**MONTGOMERY COUNTY HISTORIC PRESERVATION COMMISSION**  
**STAFF REPORT**

<b>Address:</b>	15 W. Lenox Street, Chevy Chase	<b>Meeting Date:</b>	10/11/2023
<b>Resource:</b>	Contributing Resource <b>Chevy Chase Village Historic District</b>	<b>Report Date:</b>	10/4/2023
<b>Applicant:</b>	15 W. Lenox Trust Henry Chuang, Architect	<b>Public Notice:</b>	9/27/2023
<b>Review:</b>	Historic Area Work Permit	<b>Tax Credit:</b>	n/a
<b>Case Number:</b>	984980 REVISION	<b>Staff:</b>	Dan Bruechert
<b>Proposal:</b>	Hardscape Alterations

**KAPLAN RESIDENCE**  
 15 West Lenox Street  
 Chevy Chase, MD 20815  
 19 SEPTEMBER 2023

Figure 2: Site plan from the approved 2022 HAWP.

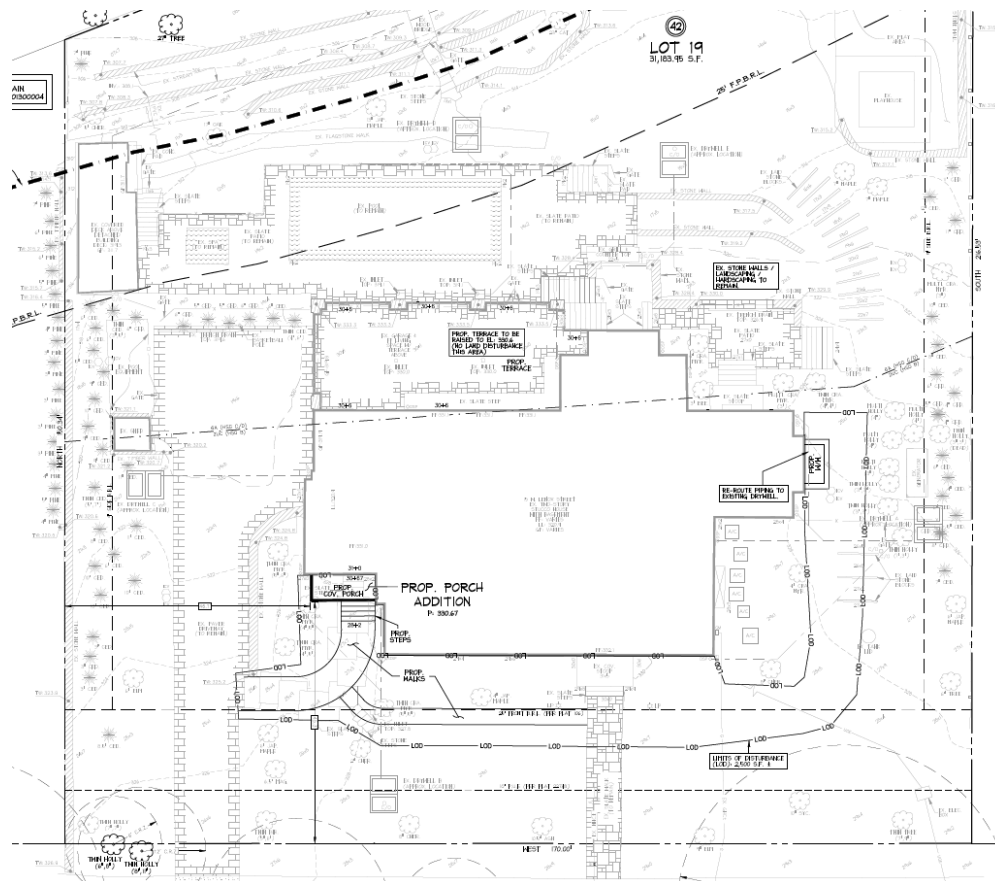
The 2022 HAWP approval included a new walkway from the driveway to a new porch, removing selected areas of existing paving, removing and replacing a stone terrace in the rear, and removing several trees.

Figure 3: Proposed site plan with the changes shown in red.

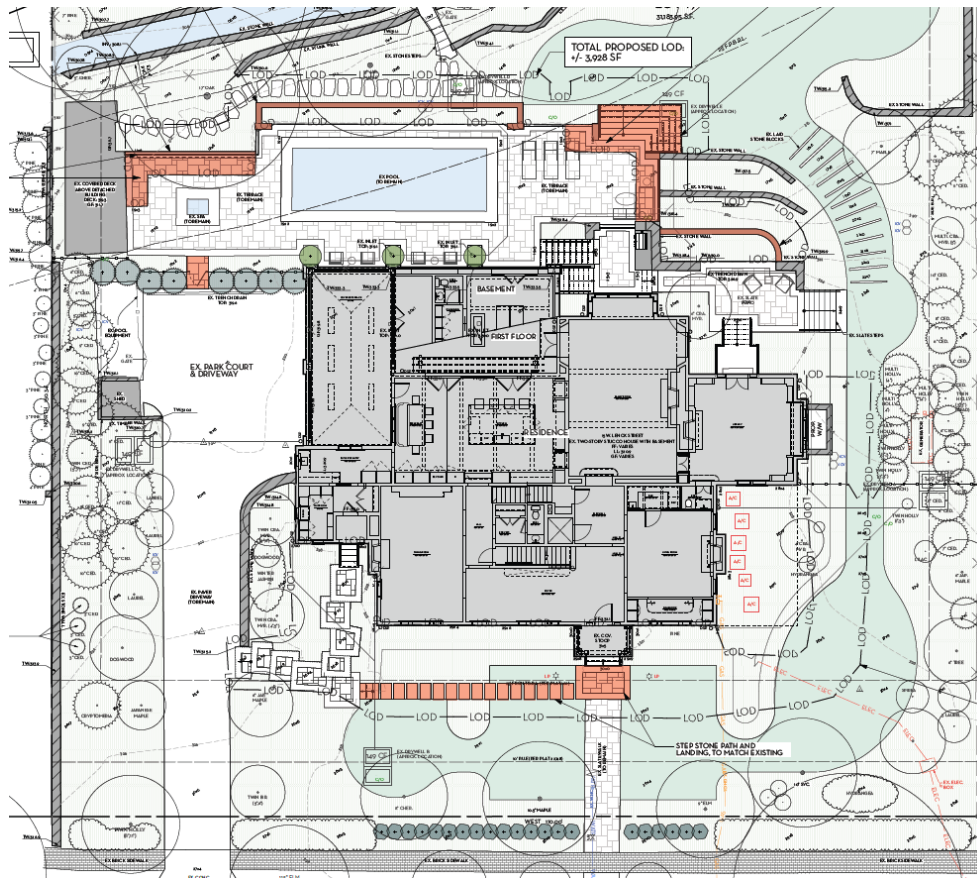
Proposed work includes a new walkway across the front of the house to the main entrance, extending the terrace on the north of the existing spa, revising the design of the stairs at the northeast corner of the rear terrace, and installing a new retaining wall (see below). All materials will match existing features on the site. No additional trees will be removed to accommodate the new hardscaping. Only the proposed walkway will be visible from the public right of way.

Staff finds the work proposed at the rear of the house will not impact any historic fabric, as it will be located adjacent to hardscaping installed as part of the 2003 site revisions. Staff additionally finds the proposed materials will match the existing features the HPC previously approved as compatible with the character of the site and surrounding district. Because no trees will be impacted by the proposed work, Staff finds the proposal will not be detrimental to the the ‘park-like’ setting of the Chevy Chase Village Historic District.

Staff additionally finds the stepping stone walkway is a revision to a walkway in the same approximate location. Staff finds the stepping stone pathway in more in keeping with the character of the site than the previously approved concrete walk. Staff additionally finds the flagstone landing at the base of the front stairs is in keeping with the character of the existing walk and is not out of scale for the property or the

surrounding streetscape. Staff recommends the HPC approve the HAWP revisions under *the Design Guidelines*, 24A-8(b)(2) and (d), and Standards 2, 9, and 10.

Staff recommends that the Commission **approve** the HAWP application; under the Criteria for Issuance in Chapter 24A-8(b)(2) and (d), and the *Chevy Chase Village Historic District Guidelines*, having found that the proposal will not substantially alter the exterior features of the historic resource and is compatible in character with the district and the purposes of Chapter 24A;
